General Contractor for Sterling Hall School – Campus Expansion Project

ADDENDUM #8 – AUGUST 6, 2026

RESPONSES TO CLARIFICATION QUESTIONS RECEIVED

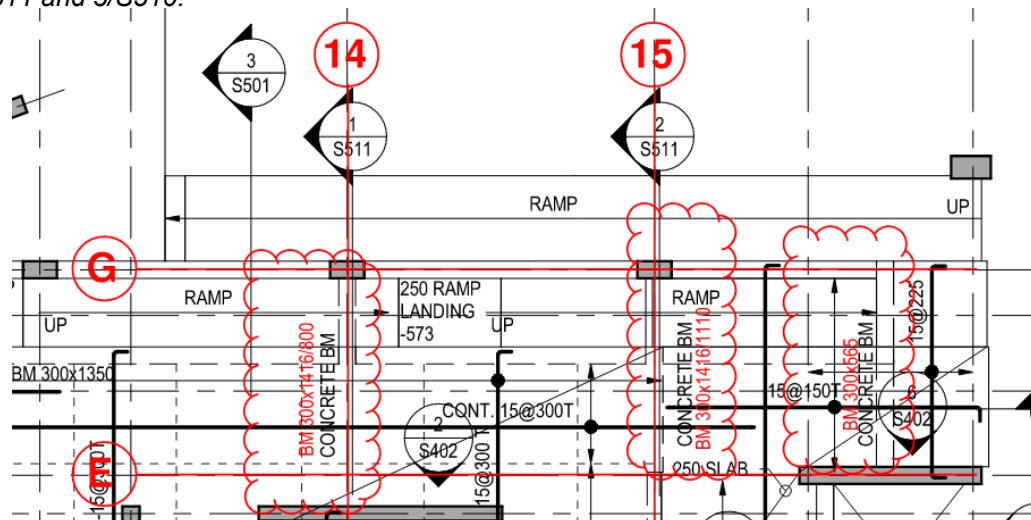
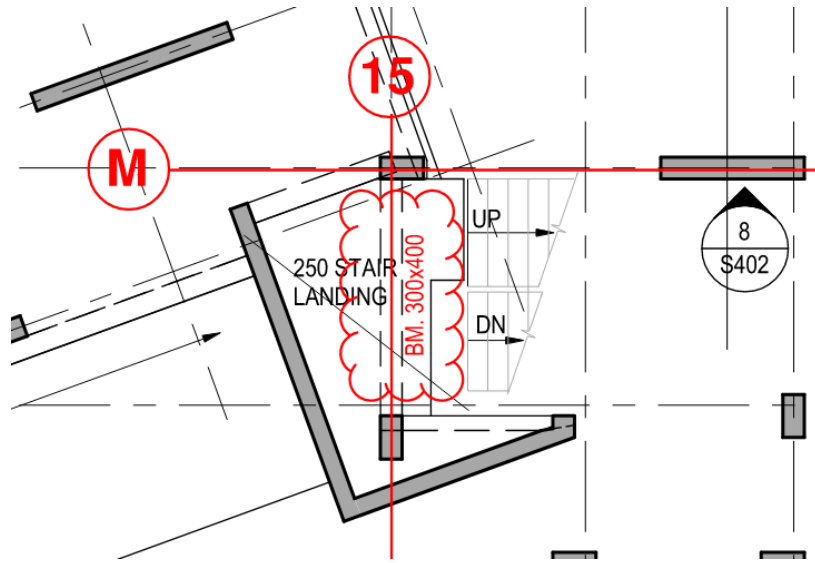
4. Concrete beams shown on Drawing S220 are missing sizes, can you please update this Drawing?

Please see below snippets of marked up S220 for concrete beam sizes. Also refer to section 1/S511, 2/S511 and 3/S510.
